Type Coffee Vending Machine	Model KORO PRIME – KORINTO PRIME	N° T.I. 07 - 2022					
Serial Number 22420254	Subject MODIFICATION OF CAPACITIVE KEYPAD ASSEMBLY	ISSUED FOR (X)	<table border="1"> <tr> <td>Action</td> <td></td> </tr> <tr> <td>Information</td> <td>X</td> </tr> </table>	Action		Information	X
Action							
Information	X

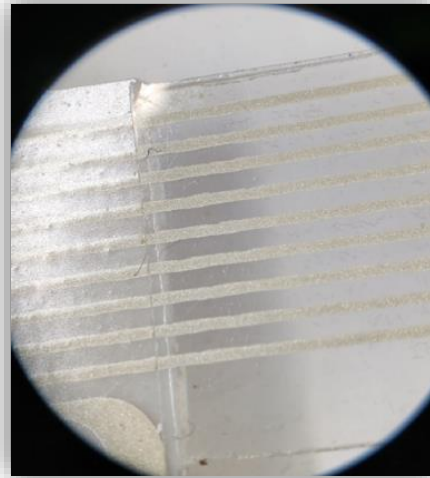
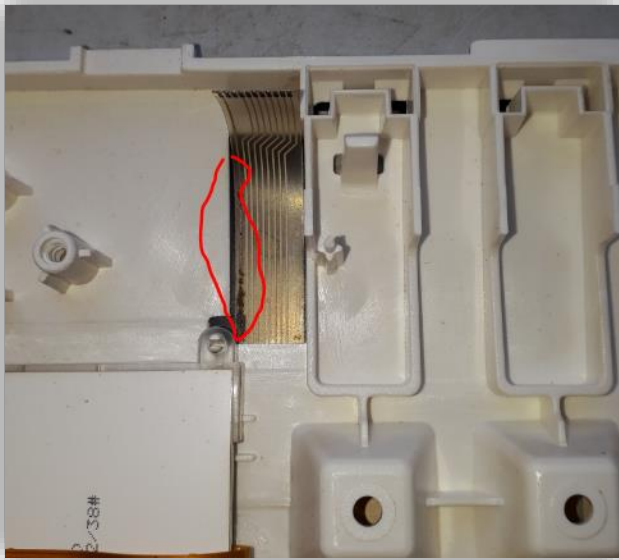
the production process of the capacitive board **flat cable** has been improved.

We introduced a *protective polyethylene layer* on the TOP surface of the **flat cable**. Previously it was only protected by conformal coating.
